Consultants Final Lot Grading Certification Letter

Re: Municipal Address: 1347 Harrington Street
Lot or Block No.: Lot 28
Registered Plan No.: 2021-0284
Certification of building and final lot grading
Bellaire Properties Inc.

1347 HARRINGTON STREET
LOT 28, PLAN 51M-1088
PHASE 2, STAGE
BELLAIRE PROPERTIES INC.
PARCEL P1 - LEFROY
TOWN OF INNISFIL

A-1

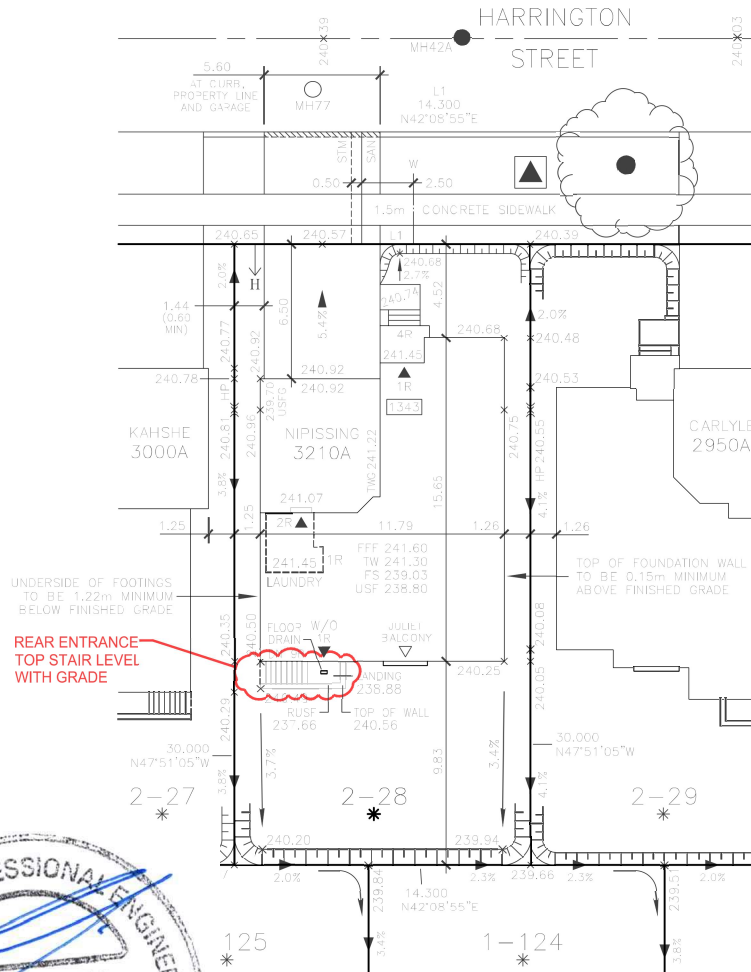
1. The lot grading and building elevations on the above referenced lot are:
 - ☐ In conformity with the approved grading and site plans
 - ☒ Not in conformity with the approved plan, but have been constructed in accordance to sound engineering principles and vary from the approved plan as shown on the attached "as-built" plan, signed and stamped by the undersigned, subject to approval by the Town of Innisfil.
2. The water service "curb-stop" is located in the grassed portion of the front yard, is accessible, and is flush with finished grade.
